Warranty Bulletin

no. 81-1

MODEL: 125 MX-8

Subject: Timing box removal

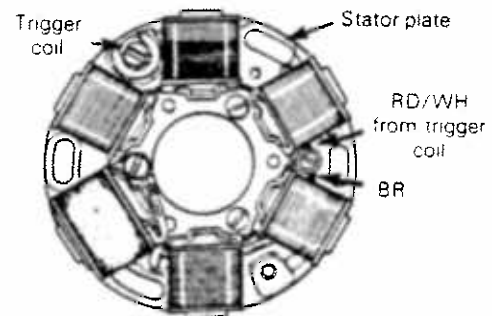
The ignition timing box may become faulty on some of the above mentioned vehicles.

If this situation happens, it is possible to remove the original timing box from the ignition system and readjust the ignition timing.

○ NOTE: This modification may change engine power curve.

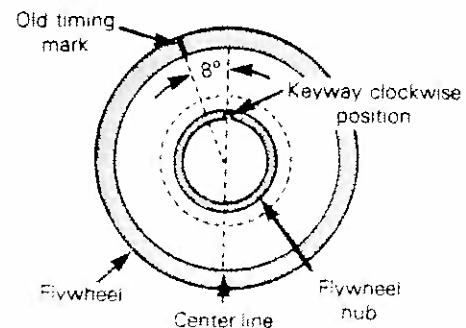
- Cut the RD/WH wire from trigger coil and ground it to the stator plate BR wire using a ring terminal P/N 730 350 001.

- Position the trigger coil WH wire to the "WHITE" position of the C.D.I. connector block. (Position II).
- Remove the flywheel hub from the flywheel and clean the flywheel surface from Loctite residue.
- Fit the new flywheel hub with its key way positioned approximately eight (8) degrees angle clockwise from the old timing mark.

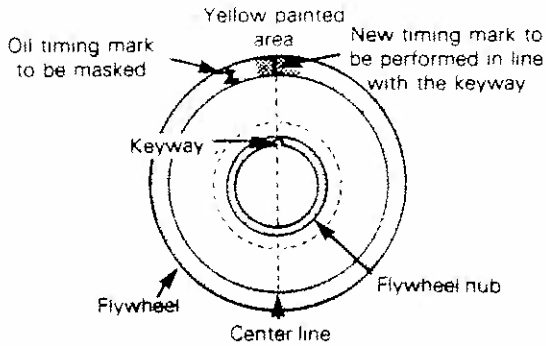
▼ CAUTION: Before assembly apply Loctite 242 (blue) to the flywheel hub mating surface.

▼ CAUTION: It is of the utmost importance to replace the old flywheel hub by the new one otherwise damage to engine will occur.

- Secure the new flywheel hub with the eight (8) screws. Torque to 6 N•m (4 ft-lbs).
- Make a new flywheel mark on the flywheel in line with the key way.
- Mask the old timing mark and apply yellow paint to the new timing mark area.
